ADDENDUM NO. 1

ISSUE DATE: August 14, 2017

FLC Harris Center Fine Arts Tile Wall Repair

LRCCD BID NO. 17028

PARAPET CAP AT STONE VENEER WALL

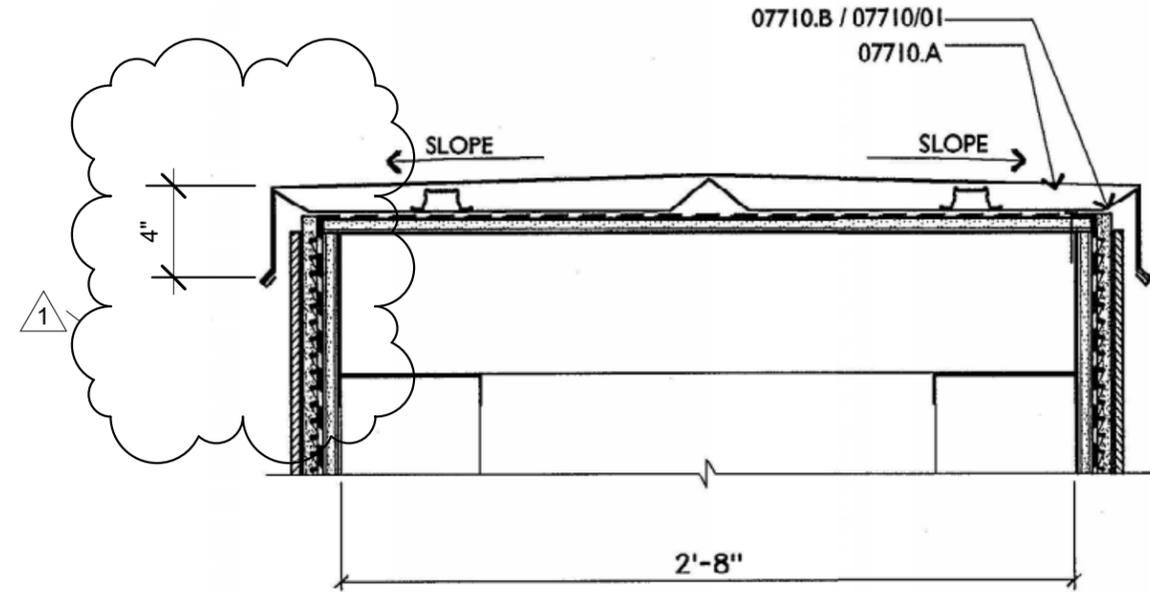
- 1. REMOVE AND REPLACE SECTION 01 25 00 WITH ATTACHED DOCUMENT.**
- 2. ADD PARAPET CAP AT STONE VENEER WALL ATTACHMENT.**
